Subject: Bid Package #1
Borel Middle School HVAC Replcmt-DSA 01-119557
College Park Elementary School HVAC Replcmt-DSA 01 119530
Meadow Heights Elementary School HVAC Replcmt DSA 01-119554
North Shoreview Montessori School HVAC Replcmt DSA 01-119526
San Mateo - Foster City School District

ADDENDUM NO. 1

Subject: Borel Middle School HVAC Replacement
San Mateo - Foster City School District
Aedis Project No. 2021005
DSA Application #01-119557

ADDENDUM NO. 1

SHEET # AD1-A1.02

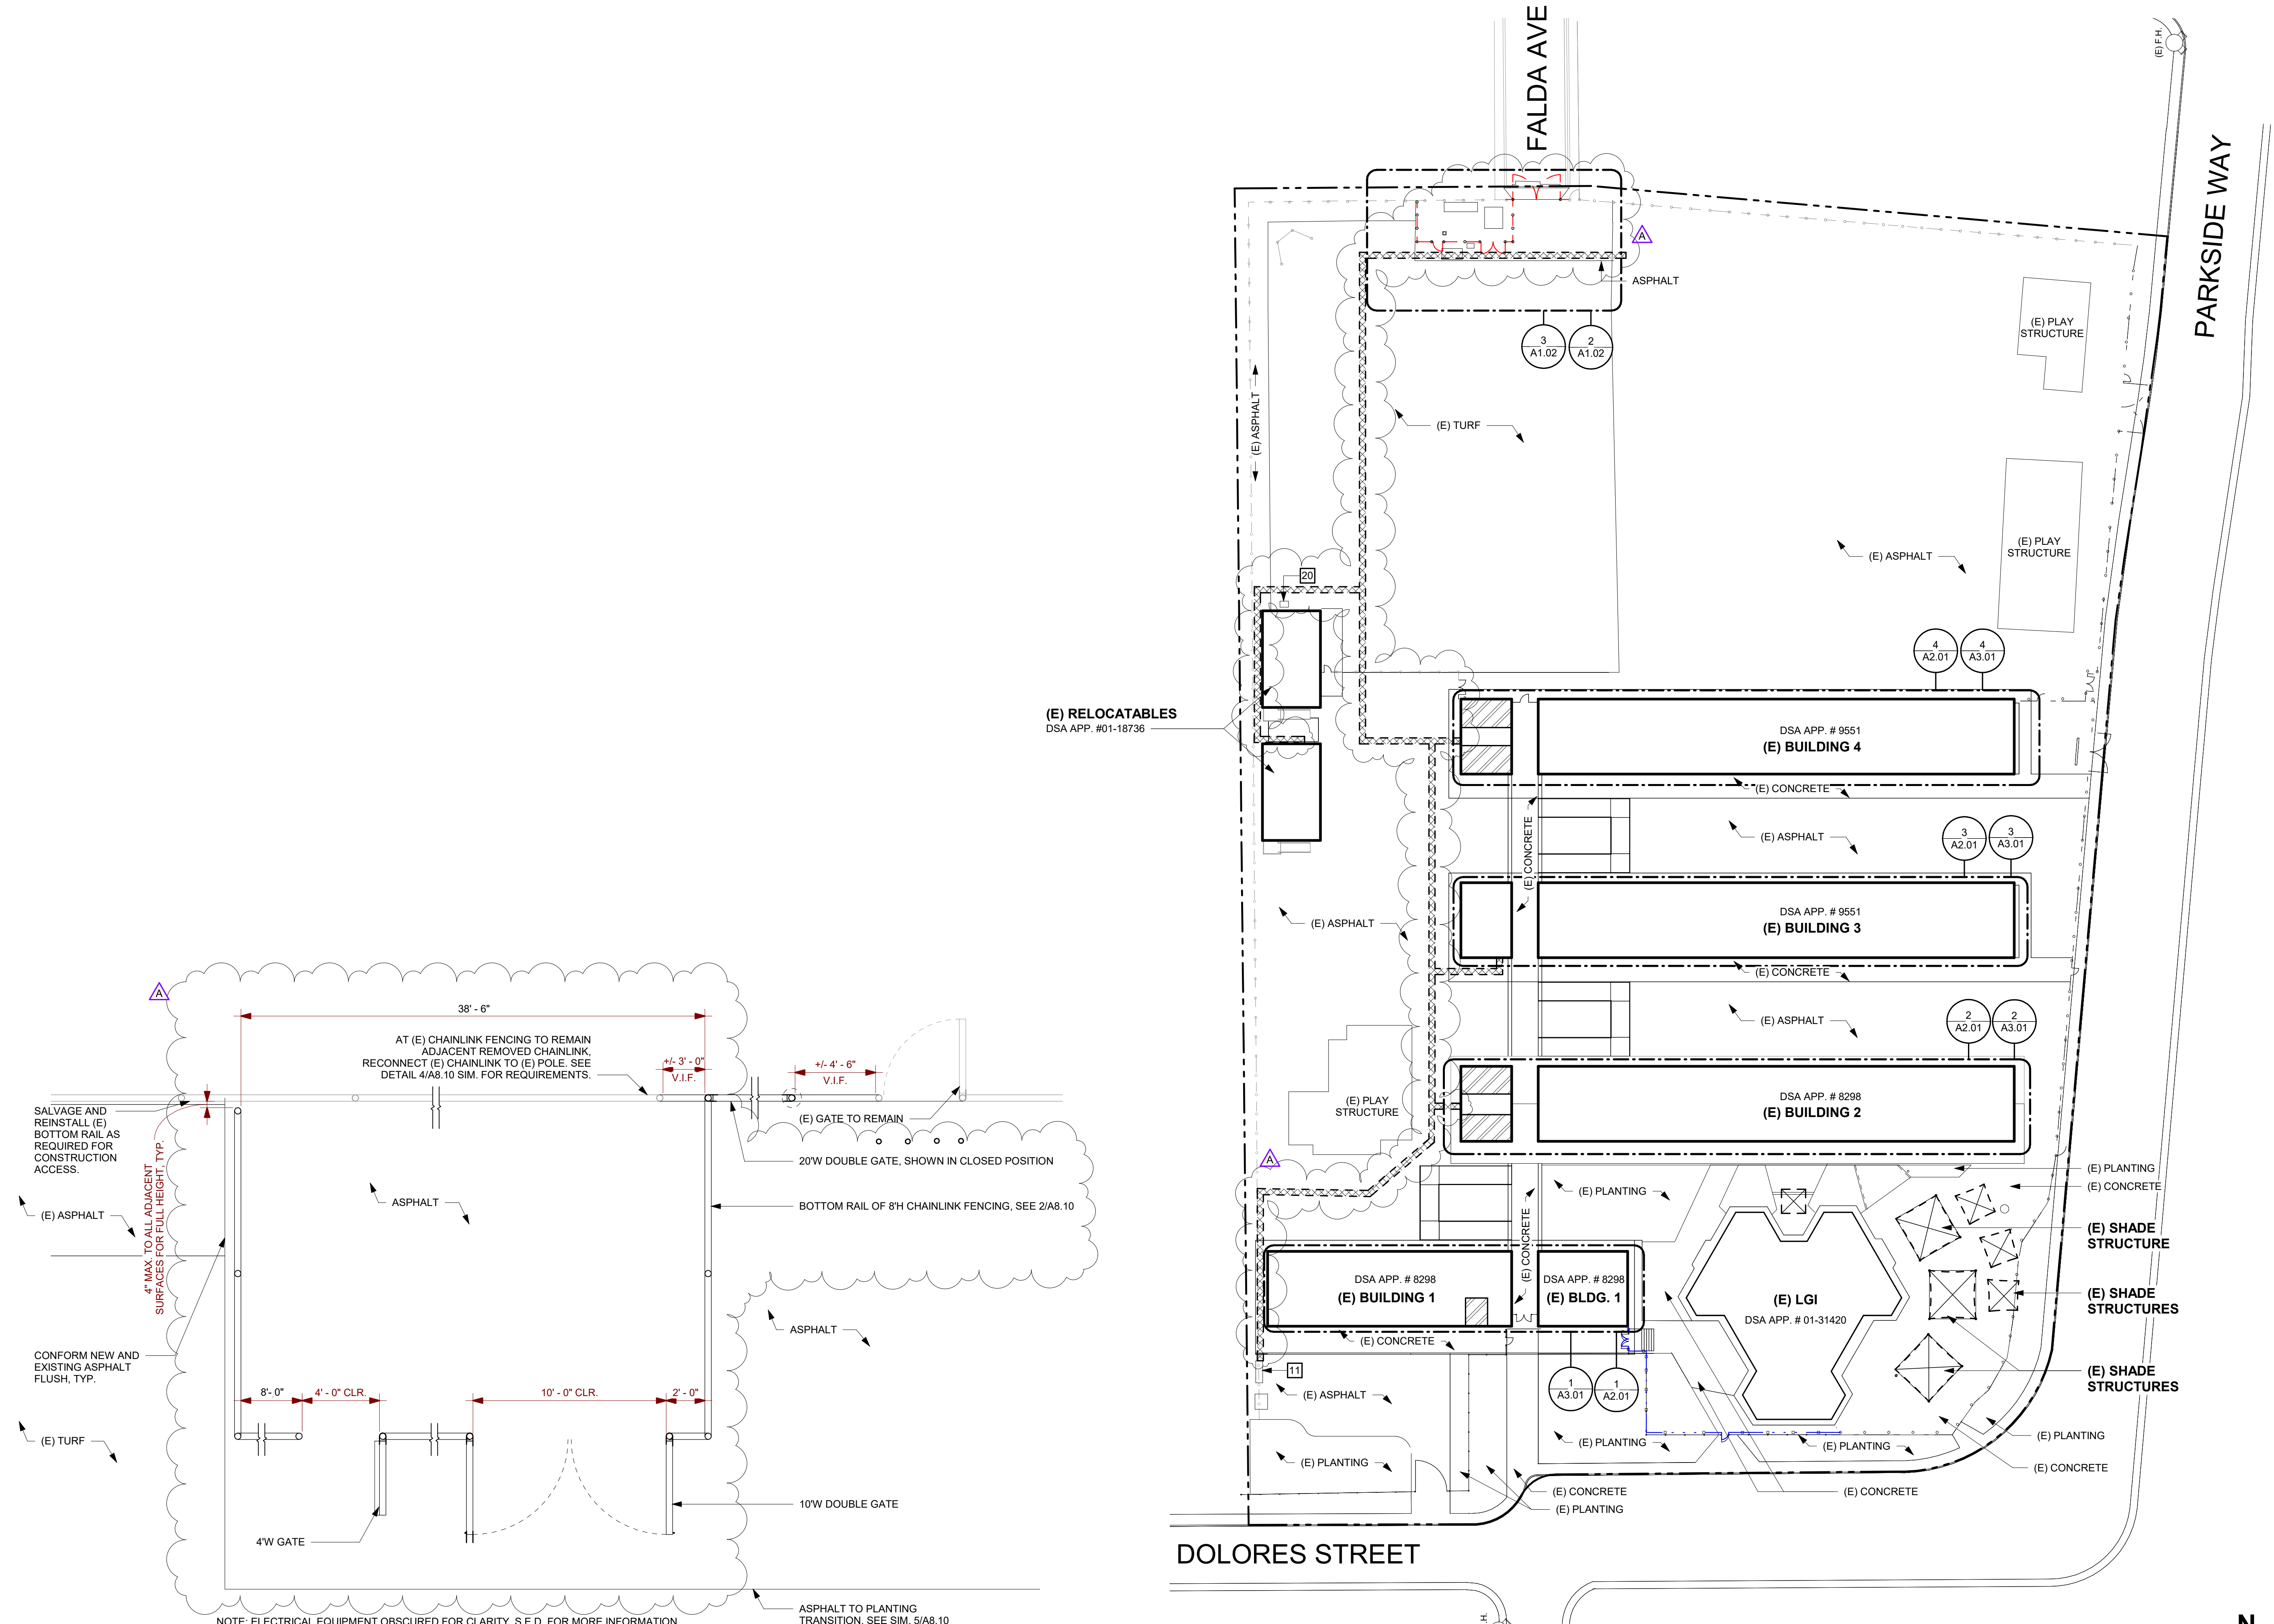
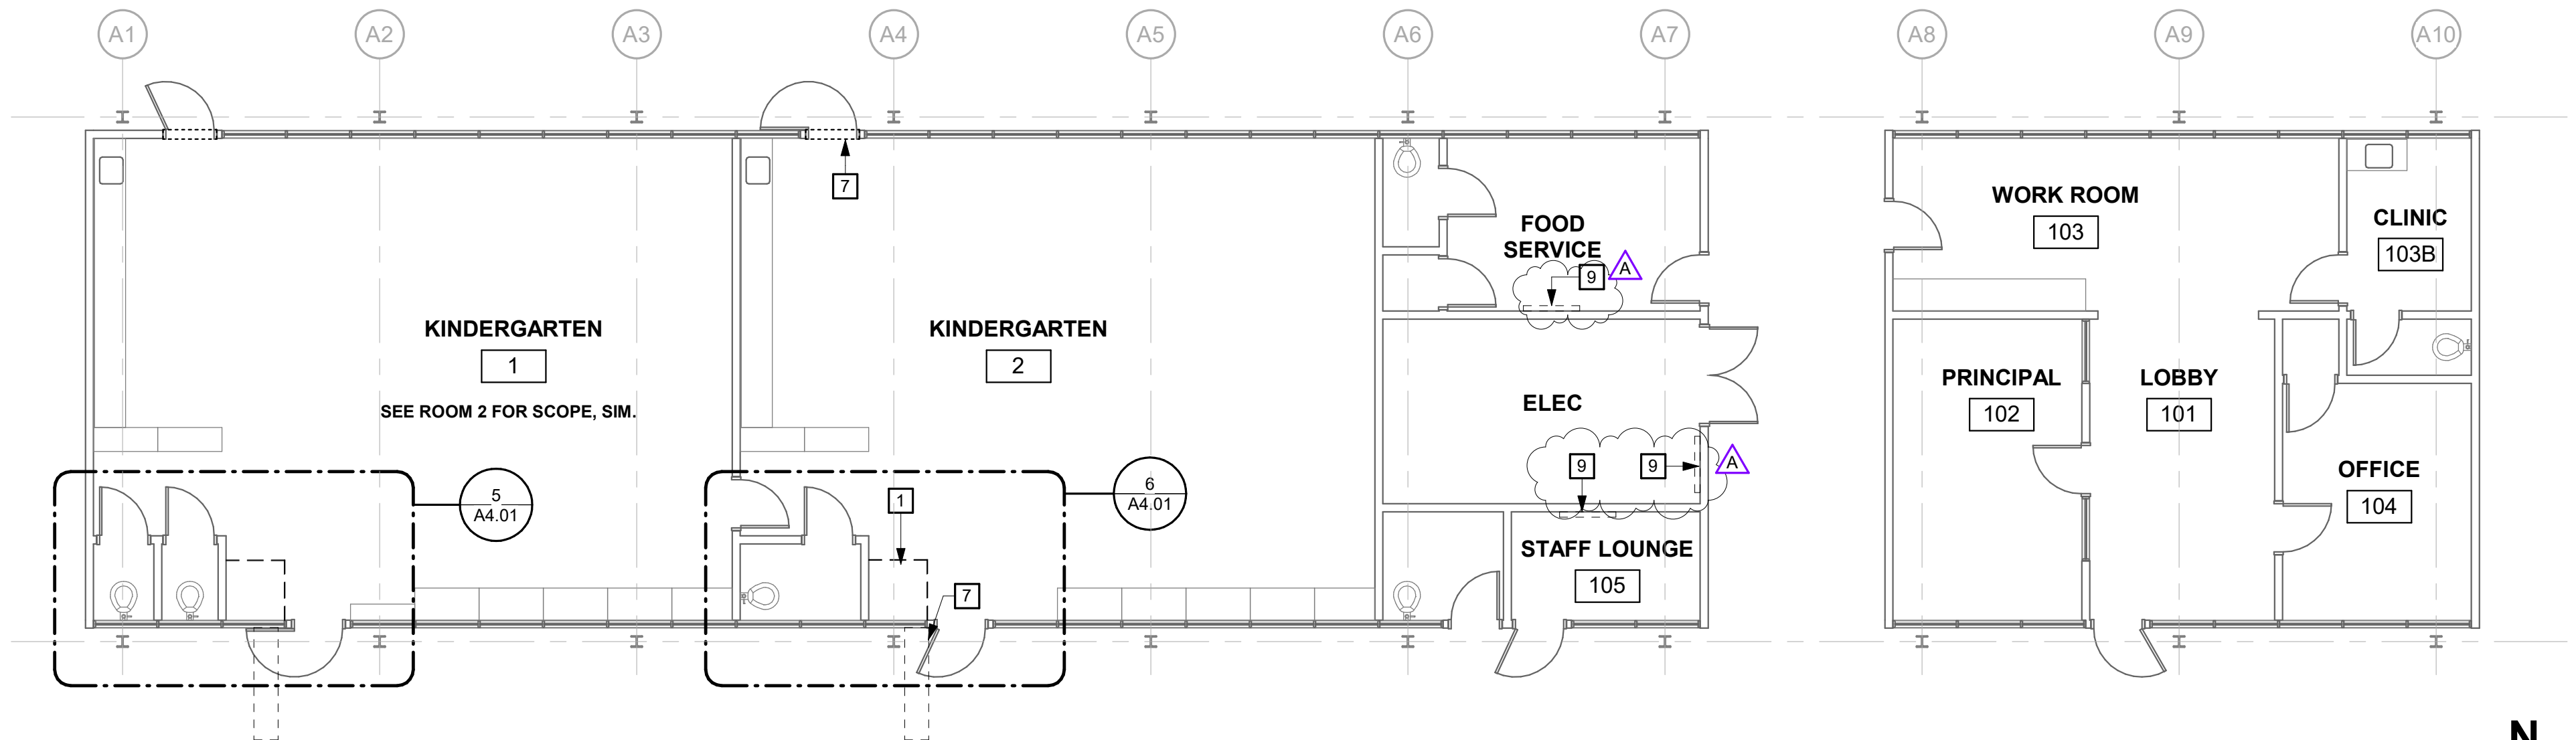
Add: Trenching area to New Site Plan 1/A1.02 and Graphic Key per AD1-A1.02

Revise: Enlarged New Site Plan 2/A1.02 per AD1-A1.02

Revise: Enlarged Demolition Site Plan 3/A1.02 per AD1-A1.02

Revise: Electrical Enclosure Enlarged Layout 4/A1.02 per AD1-A1.02

4 DEMOLITION FLOOR PLAN - BLDG 4
SCALE: 1/8" = 1'-0"

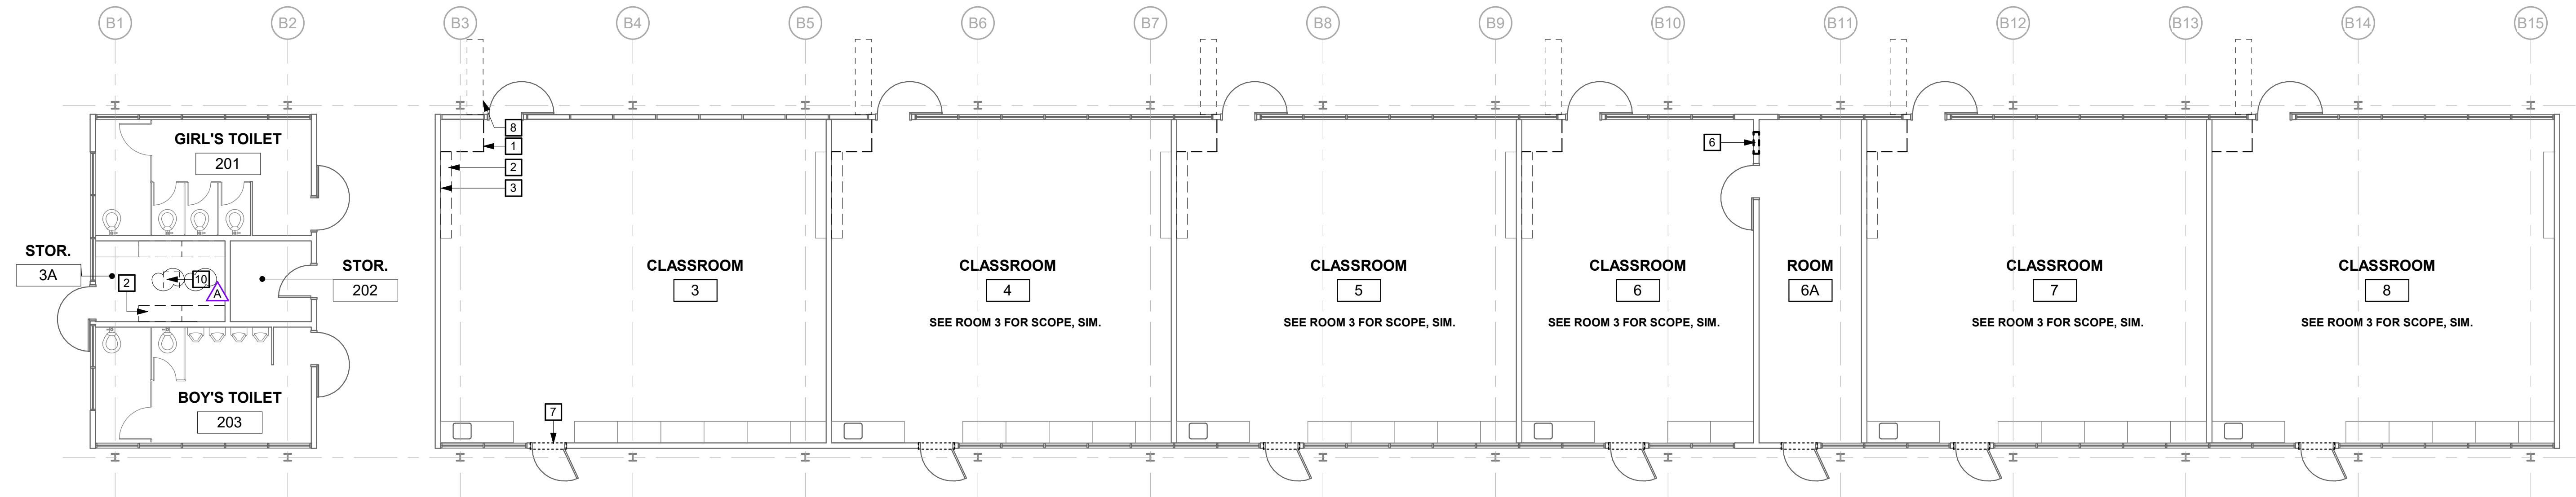
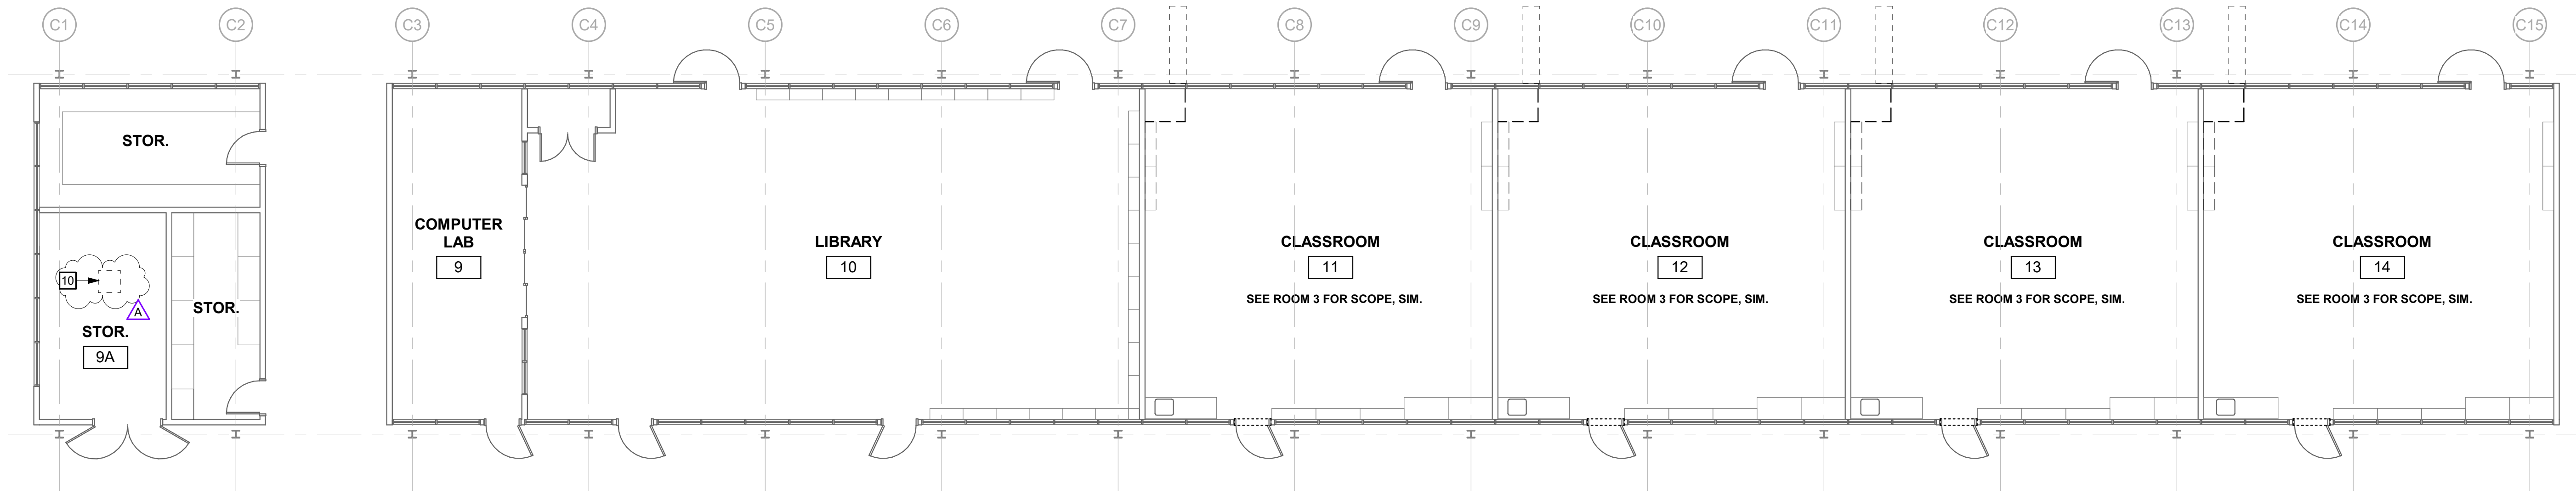
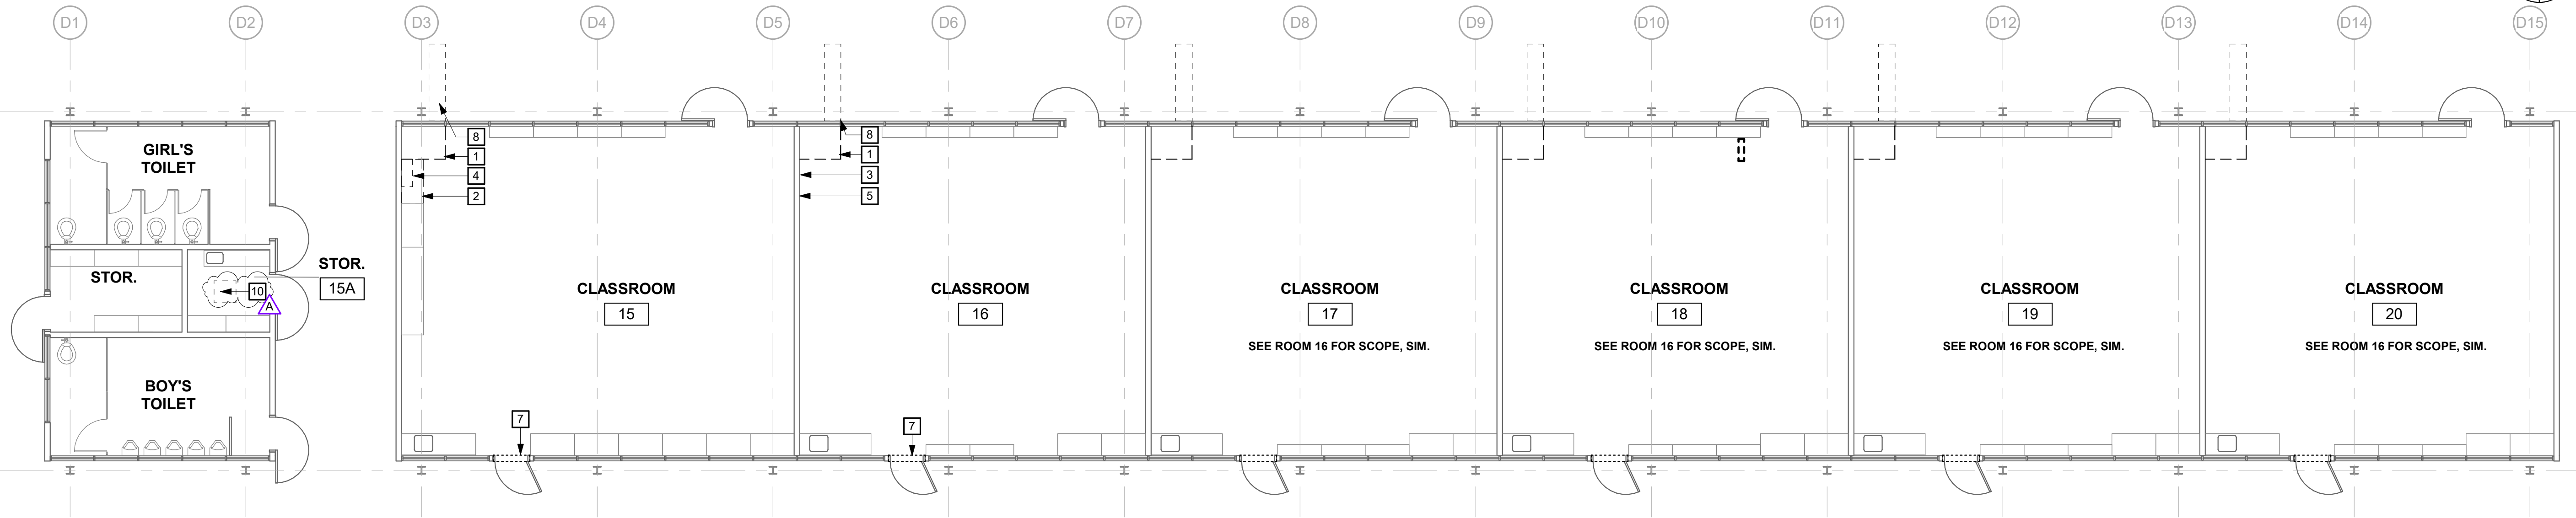
Revise: Demolition Keynote 1 per AD1-A2.01
Add: General Sheet Note #J per AD1-A2.01
Add: Demolition prep keynote #9 at Demolition Floor Plan 1/A2.01 per AD1-A2.01
Add: Partial ceiling demolition keynote #10 at Demolition Floor Plans 2/A2.01, 3/A2.01, and 4/A2.01 per AD1-A2.01
